# 3421 RAINIER AVE S

ARCHITECT   SKIDMORE JANETTE ARCHITECTURE PLANNING & DESIGN	1 - 3	PROJECT OVERVIEW
OWNER   RAINIER PHOENIX LLC	4 - 13	EARLY DESIGN GUIDANCE STUDIES, MASSINGS & OPTIONS
SDCI PROJECT #   3028934-LU	14 - 16	EARLY DESIGN GUIDANCE RESPONSES
DESIGN REVIEW RECOMMENDATION   SOUTHEAST DESIGN REVIEW BOARD APRIL 19, 2021	17	SITE PLAN
	18 - 22	FLOOR PLANS
	23 - 26	AERIAL, STREET & AMENITY VIEWS
	27 - 29	BUILDING ELEVATIONS
	30	MATERIALS
	31 - 43	ADDITIONAL ANALYSIS
	44	EARLY DESIGN GUIDANCE PACKAGE APPENDIX

EARLY DESIGN GUIDANCE RESPONSES

RECOMMENDATION  
4/19/2021 #3028934-LU

EDG OPTION A | LOOKING NORTHEAST

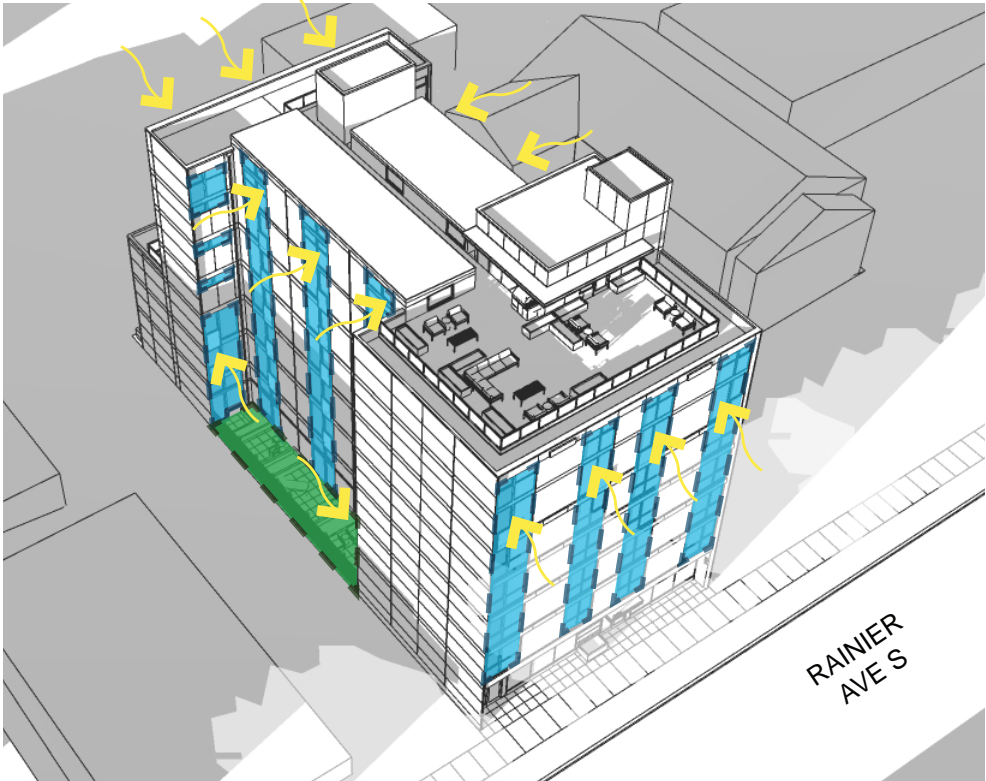
1) Livability – Access to Light and Air:

The board discussed the essential requirement for small efficiency dwelling units (SEDU) to have access to light and air.

a) After thoughtful discussion the Board thought that option A was a better fit to organize the SEDU units so that the apartments had the opportunity for more light and air. It appeared that a longer exterior wall, as shown in option A, was a good response to encourage more than one window or larger windows. The other options had very short exterior walls and limited area for window assemblies which the board thought would be necessary for units to gain access to light and air and directed the applicant to include them.

b) The creative sawtooth facades of Option C were favored by many of the Board, but the very narrow units at the interior of the building looked to be devoid of much light and usable space. They directed the applicant to combine some of the units to allow for larger light and air opportunities.

The proposed design is an evolution of Option A, with central courtyards on both the north and south property lines and the rest of the units either facing the east or west towards the right of ways. The courtyards allow for large windows for the central units, with similar generous windows on the east and west facades of the building.

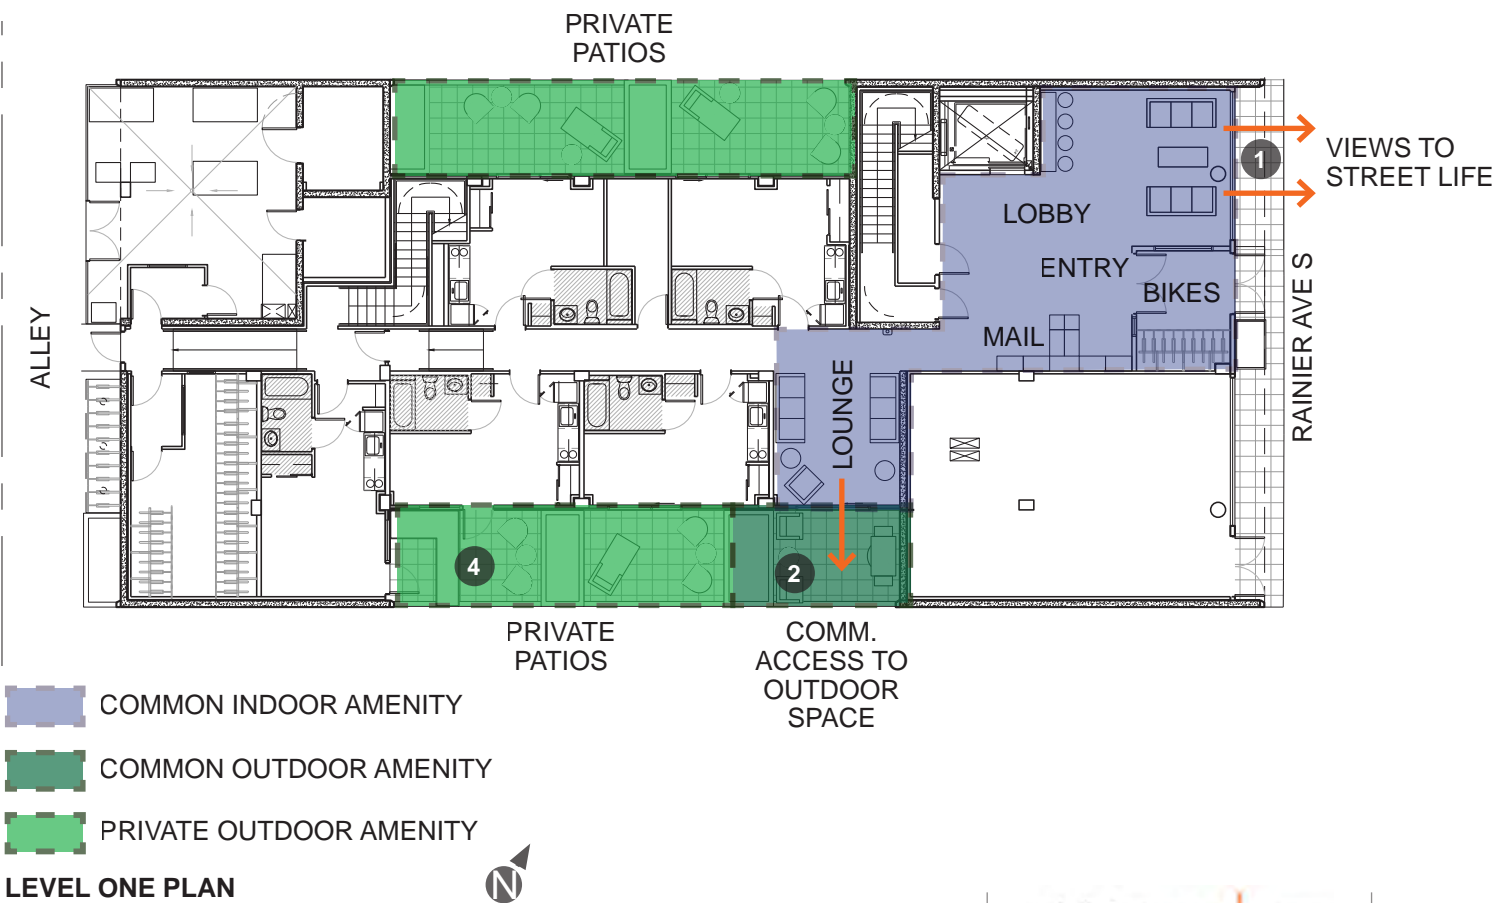
2) Livability – Open Space:

The board focused on the nature of the small efficiency dwelling units (SEDU) as very small apartments and the inherent need to have outdoor open space maximized on the site for both communal gathering and private open space.

- a) The board asked the project team to minimize circulation routes and maximize the usable open space at ground level. They suggested limiting dwelling access to the central corridor only with the live work accessed off it. They pointed out that with a central corridor, ground floor units (both north and south) would have highly valued access to private outdoor space.
- b) The board thought there were several ground floor options to enhance the availability of open space.
- c) The board asked the architect to provide a more complete landscape plan to better study the open space options and offerings. The board asked for quality outdoor open space that is not used for circulation.
- d) The board also asked for interior amenity spaces for residents. They suggested that it could be combined with a lobby at ground floor or elsewhere in the building.

The live work units on the ground floor and side courtyard access to Rainier Ave S that were shown in option C at the EDG meeting have been removed. They have been replaced with centrally located north and south courtyards accessed from the units as presented in the board’s preferred Option A. This results in less of the open space being dedicated to circulation and maximizes the usable open space directly adjacent to the ground floor units. All ground floor units have access to a portion of the courtyard, with planters and screens providing privacy between the individual spaces. Generous interior amenity spaces have been provided at the ground floor, with a large lobby that includes important lobby functions (mail, bike storage, access to stairs / elevator) as well as providing areas for resident use, either individually or as a group. A common area near the lobby entry looks out over the street and sidewalk, providing an internal location for residents to meet others, wait for rideshares or deliveries, and observe Rainier Ave S, maintaining eyes on the street. An additional lounge area adjacent to the lobby affords access to the south courtyard, creating an interior space with the opportunity to expand to the outdoors. Further outdoor amenity space is located at the west setback, as private amenity to the north and south, and a central common amenity space accessed off the corridor. Another large common deck, positioned on the east portion of the roof, allows for more exterior gathering space, flanked by green roof with deck planters separating individual spaces. Additional information, including complete landscape plans, will be provided in the forthcoming recommendation packet.

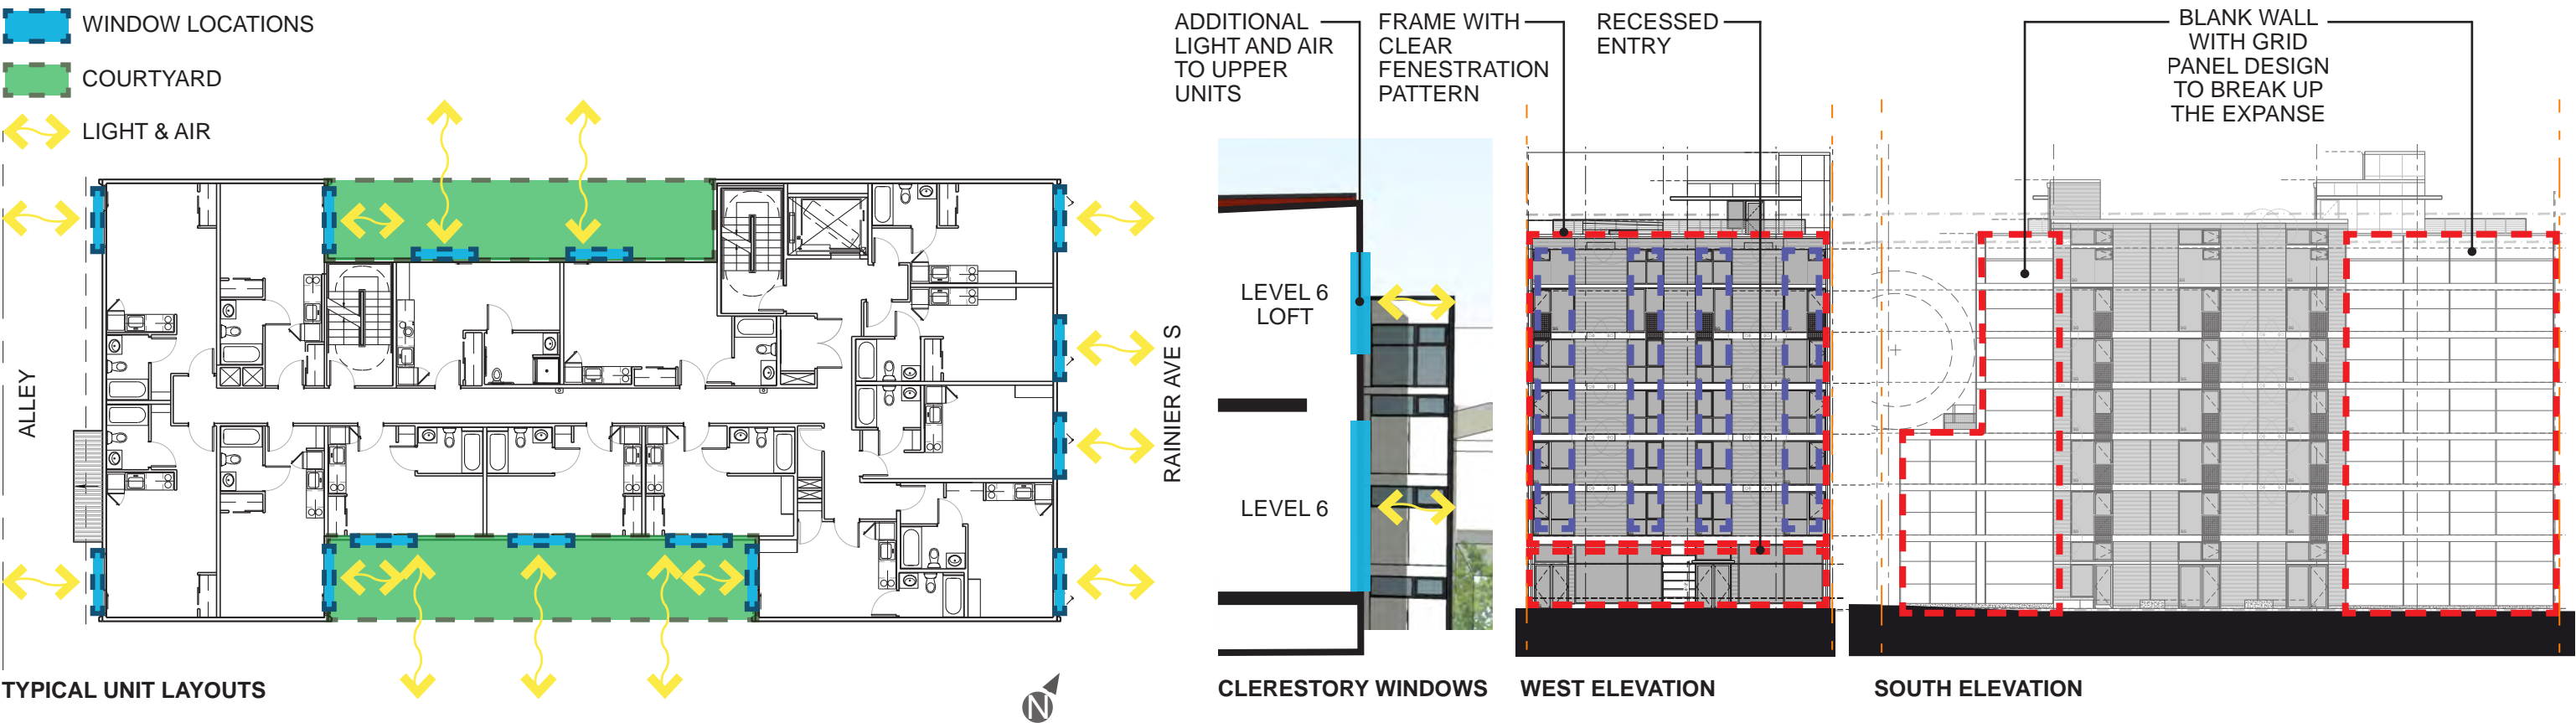
3) Height, Bulk, and Scale

The board discussed the presented options and the height, bulk, and scale response to the neighborhood.

- a) The board was split on their approval of massing options and discussed the merits of Option C with the interesting sawtooth facades and Option A with mid-site opportunities for ground level open space and north and south units larger access to light and air. The Board directed the applicant to maximize light and air and open space availability and noted that mixing bulk and scale from the various options would be welcomed.
- b) The board directed the applicant to avoid bank walls at the site. Windows, interesting façade materials, green walls, and modulation would all serve to mitigate any blank wall areas.
- c) The board commented that the modulated front façade was a positive element and asked that it be explored for further development but understood that the narrow site did not dictate front modulation.

The proposed design reflects the board’s priority of maximizing the access to light and air for as many units as possible. As the board noted, this is accomplished best by Option A, with it’s mid-site courtyards on the north and south facades. The units have been reconfigured so that the middle units are wide and shallow, maximizing their access to light and air from the adjacent courtyard. At the east and west ends of the building, the units are narrower, with large glazing directed towards the right of ways. The blank walls along the North and South portions of the site are a result of selecting option A to move forward and are modest, separated by the mid-site courtyard, and textured with panels that relate to the patterning of the rest of the building. The front (east) façade is a simple plane with clear fenestration patterning and durable materials composed in a coherent, restrained manner. An expressed frame element encloses the façade, creating visual interest through planar relief and linking the recessed entries at street level to the façade on the upper stories. The frame element is repeated on the west façade and courtyard, establishing a cohesive overall composition and parti.
